of a private plan change for
the rezoning approximately
7ha of land at 157 Levi Road,
Rolleston, from Medium
Density Residential Zone to
Large Format Retail Zone
(Variation 2) by Foodstuffs
(South Island) Properties
Limited

SUPPLEMENTARY STATEMENT OF EVIDENCE OF ANDREW DAVID CARR

Figure 1: Rolleston DEV-RO12 Development Area (Left) and Mr Metherell Figure 1 (Right)

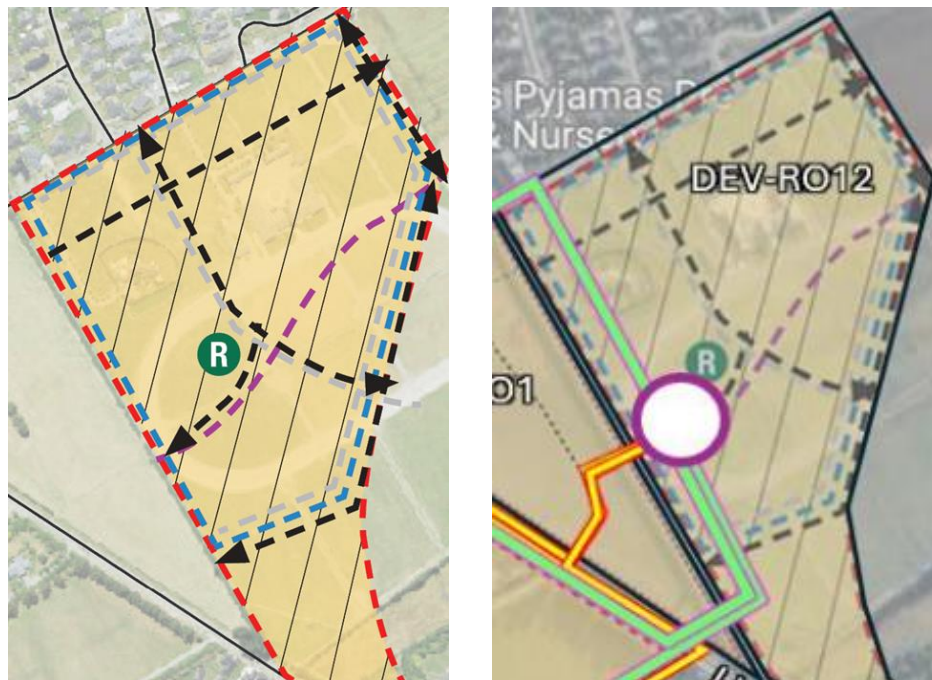
- 2.2 In paragraph 4.7 of my EiC, I set out four recommendations for revisions to the Variation provisions, to which Mr Metherell has responded. I address each below.
- 2.3 In Paragraph 4.7(a) I recommended that a non-car east-west link should be shown on the ODP to connect the site to the land to the immediate east. Mr Metherell disagrees, noting that the absence of such a link does not impose significant additional walking distance to key destinations (his Figure 1).
- 2.4 In his analysis, Mr Metherell has allowed for a walking and cycling link running north-south towards the western boundary of the Rolleston DEV-RO12 Development Area. However this route does not appear on the Development Area plan at present:

- 2.5 I note that Mr Metherell "*anticipates that changes would be made within DEV-RO12*" (his paragraph 61) in order to support pedestrian access but I am not aware that such changes are presently sought or underway. Consequently while I do not disagree with Mr Metherell's Figure 1 as such, it appears to rely on a walking and cycling connection which has no status and

may therefore not be put in place. If this north-south link was not to be present, then the walking and cycling route would be more circuitous and longer.

- 2.6 Mr Metherell also does not appear to have considered walking and cycling trips between the activities at the site and the residential area to the immediate east. These journeys would also be more circuitous without an east-west link than if the link was to be in place.

- 2.7 On this basis then, I remain of the view that a non-car east-west link should be provided for in the ODP.
- 2.8 In Paragraph 4.7(b) I recommended that the vehicle crossings associated with Pak n' Save on the ODP should be updated to reflect that some carry one-way traffic only. This matter has been addressed.

Figure 4: Concept Site Plan overlaid with Indicative Roading Scheme

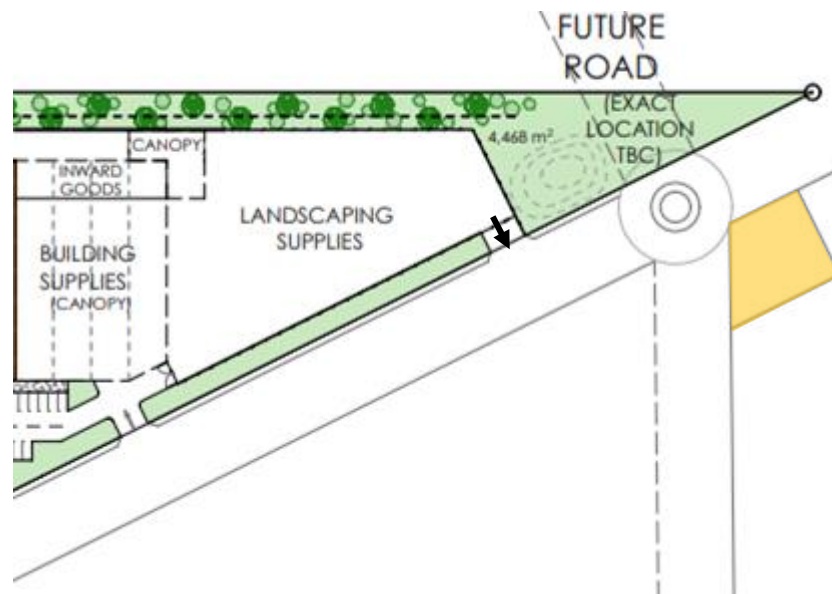
- 3.2 The drawings presented by Mr Lawn show a conflict between the signalised Lincoln Rolleston Road / Broadlands Drive intersection and the exit from the service yard. In particular, the Broadlands Drive extension is located further north than allowed for within the proposed ODP for the Site.

- 3.3 Below I show the Applicant's Concept Site Plan overlaid onto the Council's roading scheme. I have highlighted one lot with orange shading to assist with comparing the Figures:

- 3.4 It can be seen that the exit from the service yard conflicts with the roading scheme, because the vehicle crossing aligns with a pedestrian crossing and the stop-lines of the intersection. For clarity, this exit from the service yard is also shown on the Applicant's ODP.

- 3.5 The Council's roading scheme is described as "*concept plans [which] have been developed (but not necessarily finalised)*". I therefore expect that they may change. Similarly, the Applicant's Concept Site Plan might also change. My concern is therefore to ensure that there is the maximum flexibility in the exit from the site – that is, I consider it should either annotated as 'indicative' on the ODP or relocated further north to avoid this conflict. In view of the status of the roading scheme, I prefer the option of amending the wording of the ODP.

- 3.7 Mr Lawn seeks that the road alignment on the ODP is revised or shown as being an 'indicative future primary road'. I agree with his request, because although the Concept Site Plan has such an annotation, the ODP itself does not (and it is the latter which I understand has the greater weight). I therefore also agree with his requests for consequential amendments to the wording of Appendix 1 of the s42A report, except that I note that the proposed wording uses "*Broadlands Drive roundabout*". For the reasons set out by Mr Lawn, I consider that all references to the "*Broadlands Drive roundabout*" should instead be "*Broadlands Drive intersection*" as this allows for flexibility in the design.
